2CAN080301

SUBJECT: Supplement to Amendment Request to
Revise the Spent Fuel Pool Loading Pattern
Arkansas Nuclear One, Unit 2
Docket No. 50-368
License No. NPF-6

Request for Additional Information - Reactor Systems Branch
Amendment Request to Revise Spent Fuel Pool Loading Pattern
Arkansas Nuclear One, Unit 2

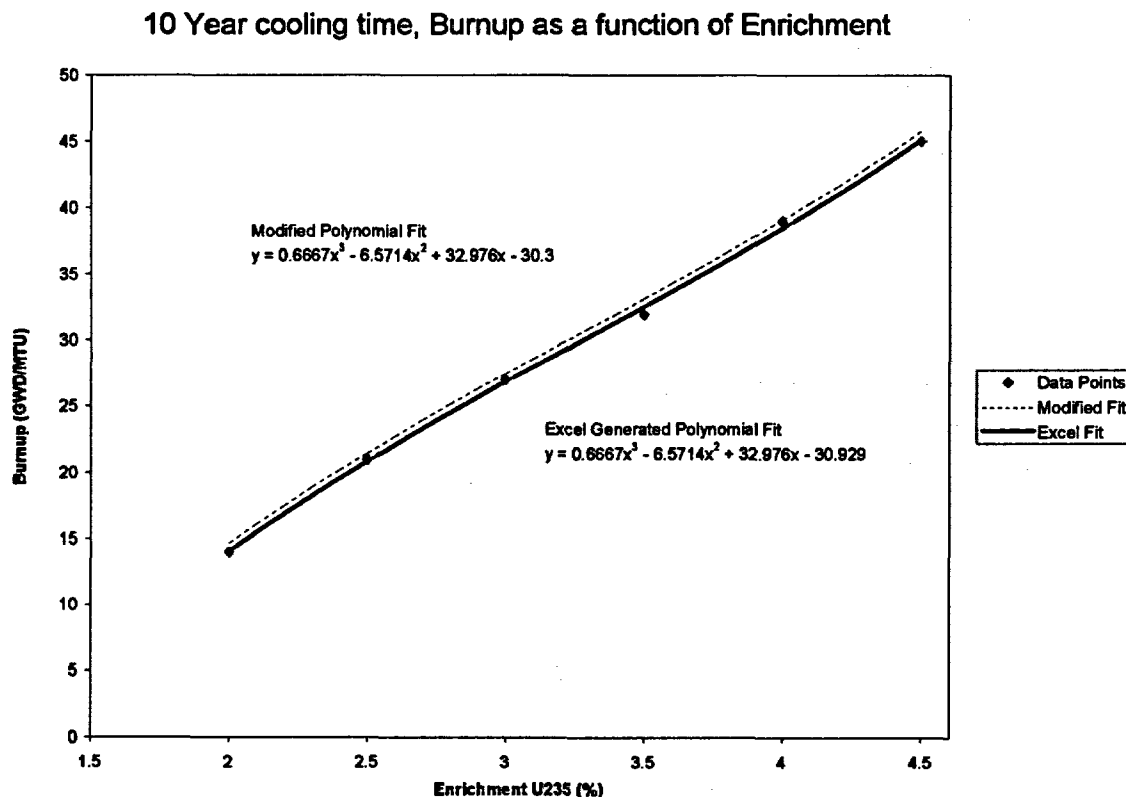
The subject of "bounding polynomials" was raised in Attachment 1 and in the Holtec report. However, no basis was provided for the number of terms included or the obtained values of

the coefficients. Please provide the technical justification and an example of how one of the polynomials is developed.

Third order polynomial fits were developed to conservatively predict the burnup requirements of the spent fuel assemblies. The calculated minimum burnup data points are plotted in Excel. A least squares 3rd order polynomial fit equation is then developed in Excel using the trend line function. The following equation is used for calculating the least squares fit:

Plotting the Excel trend line it can be seen that some of the data points are on or above the fit. The equation is revised by adjusting the constant "b" such that all data points are bounded by the revised equation. Each data point is checked to insure the revised equation conservatively predicts the required burnup. The following is an example:

In the 10 year cooling trend line graph depicted in the preceding graph, 30.929 in the Excel generated equation was conservatively adjusted to 30.3 in the modified polynomial fit equation so that all data points are bounded by the revised equation.

Figure 3.9.1

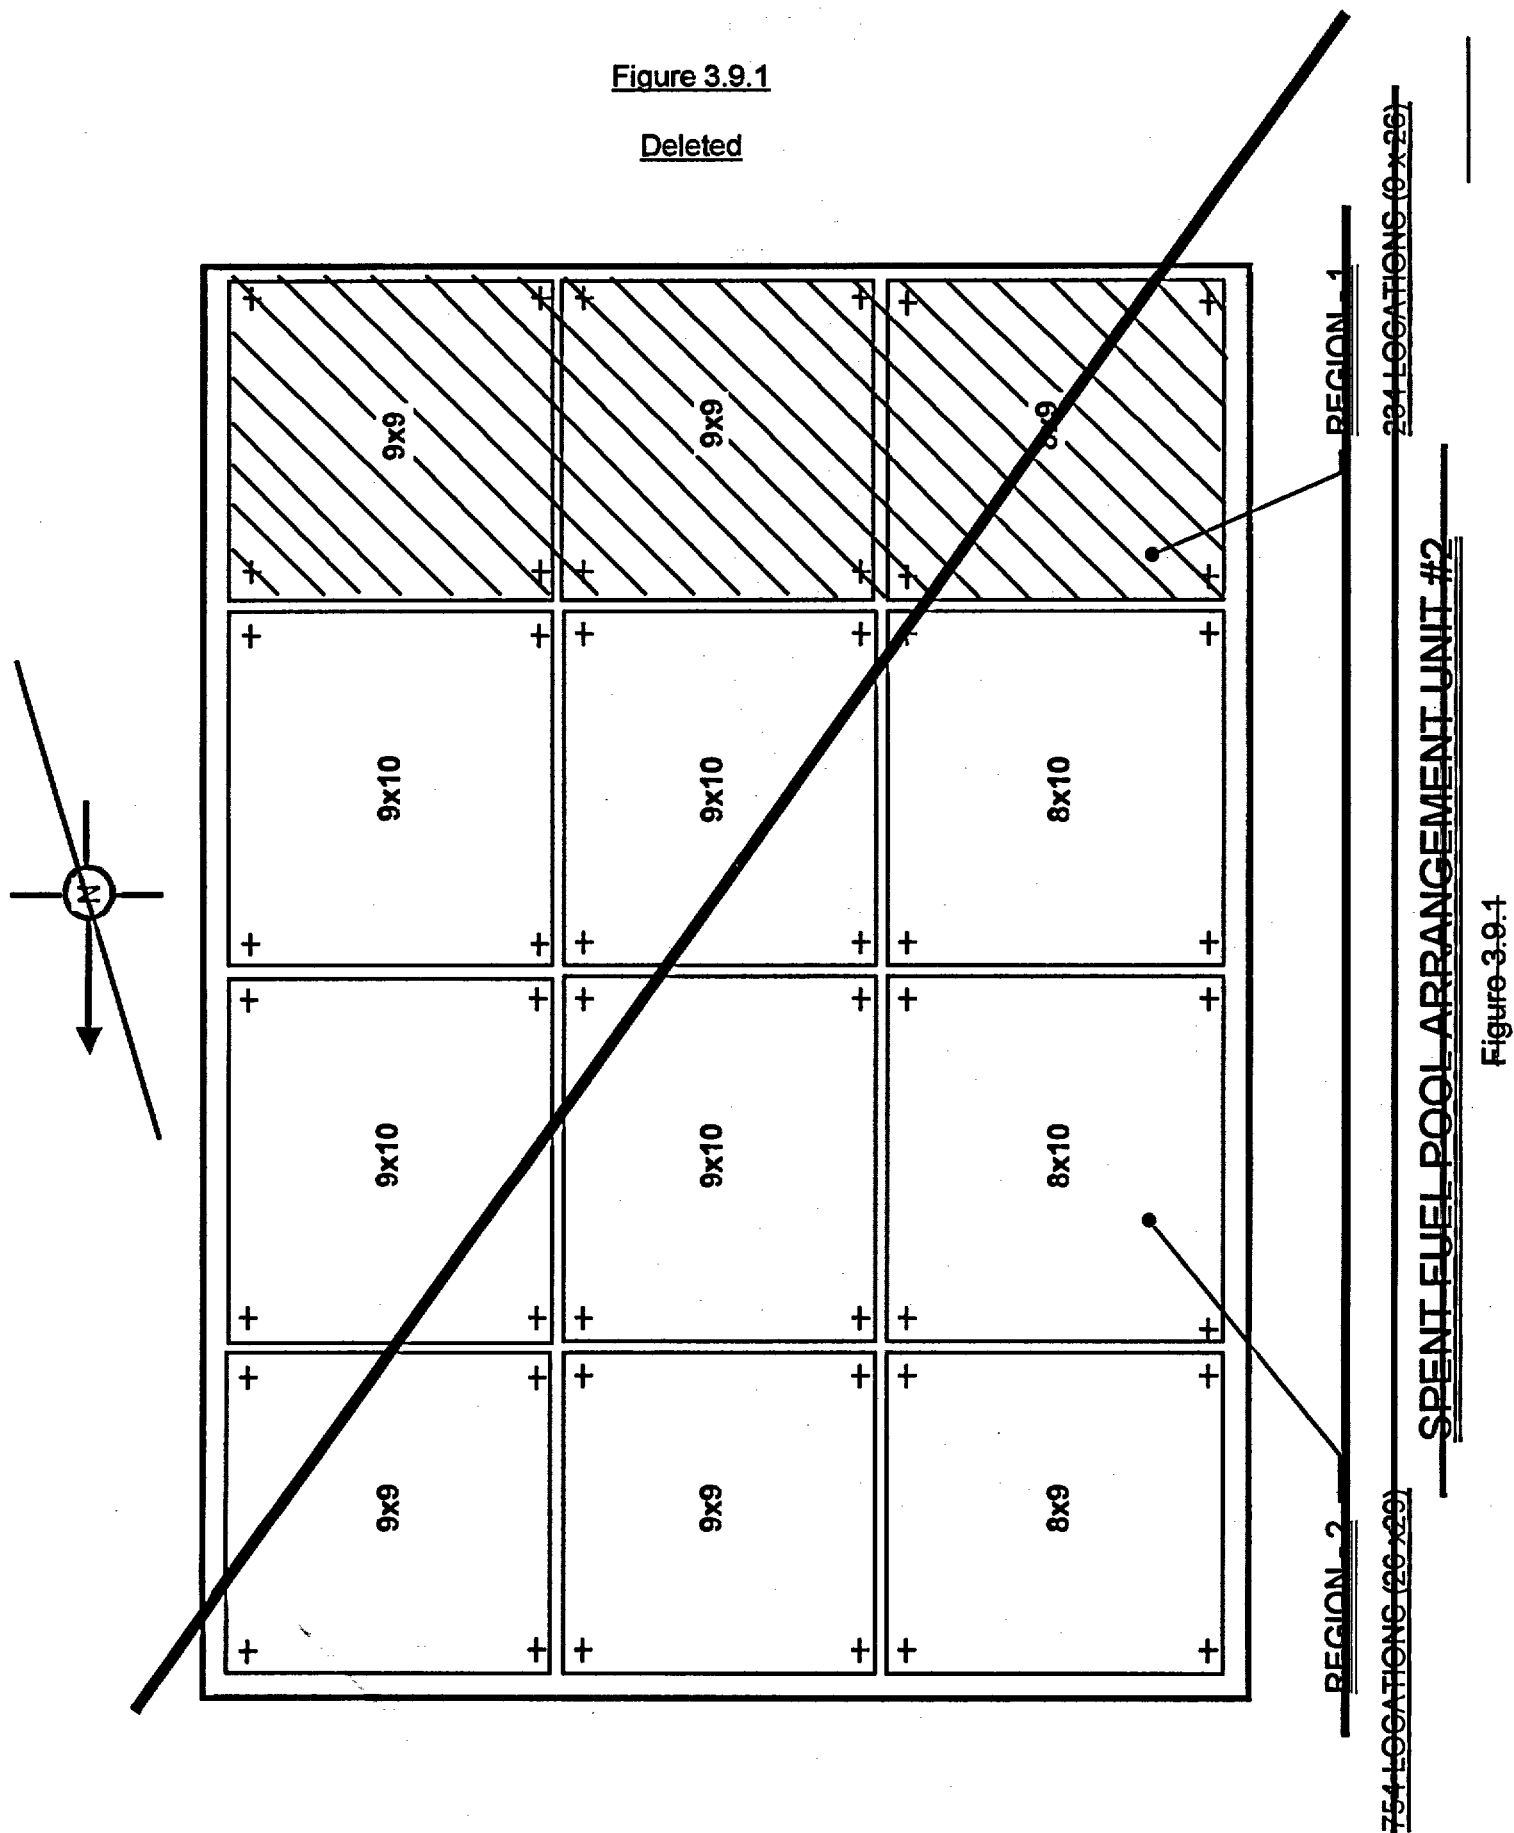
The current configuration of the spent fuel pool at ANO-2 is a two region configuration. It is not clear if this configuration has been retained for this proposed change to the ANO-2 Technical Specifications. Please provide additional clarification.

The proposed change eliminates Region 1 and Region 2. No credit will be taken for the Boraflex that is contained in the current Region 1. The proposed loading patterns and associated interfaces may be implemented at any location in the SFP. The deletion of Figure 3.9.1 is included in Attachment 2 to this letter.

Deleted
